PROJECT: Wallowa Memorial Hospital MOB  
TO: Clark/Kjos Architects\*

RE: 001-211300-Product Data / Materials - Fire Sprinkler Systems

# submittal review-fire sprinkler

Wallowa Memorial Hospital New Medical Office Building Construction			
SUBJECT / PROJECT	Documents - Enterprise, Oregon	DATE	October 6, 2011
		Review of Submittal #s: 100-211300-001 (Drawings), 300-211300-001 (Calcs), and 001-211300-001 (Product Data)	
PROJECT NO.	2010-0202.01	REF #	
CLIENT	Arthur Kjos, Partner	PHONE	X 203
Clark Kjos Architects			
333 NW 5th Avenue			
Portland, OR 97209			
REVIEWED BY	Kathleen Roach, CET, CFPS	@	Interface Engineering, Inc.

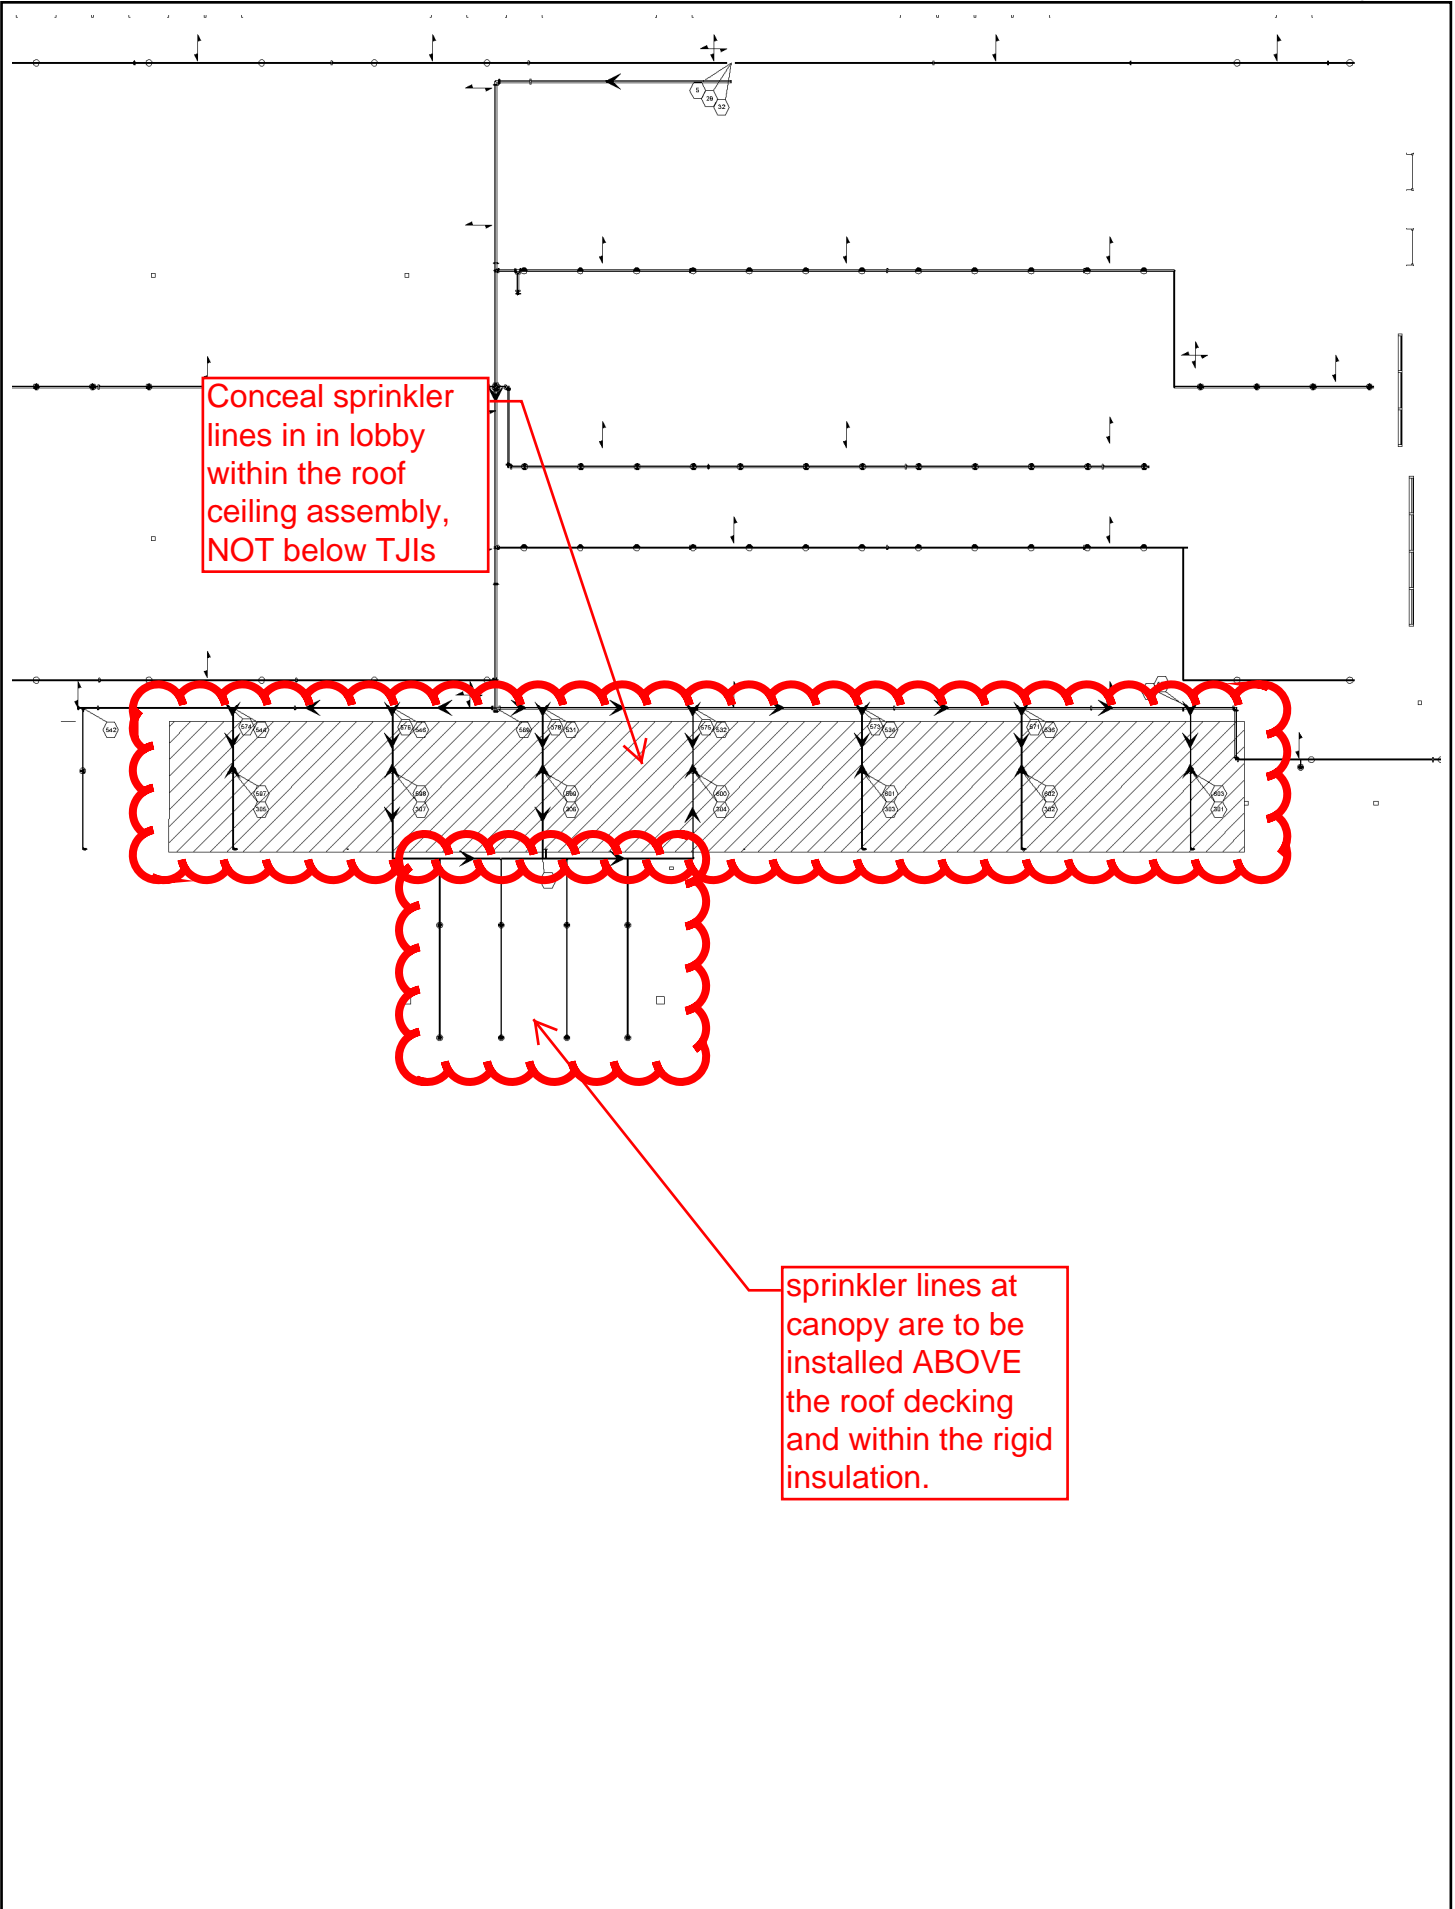
walkway not in project
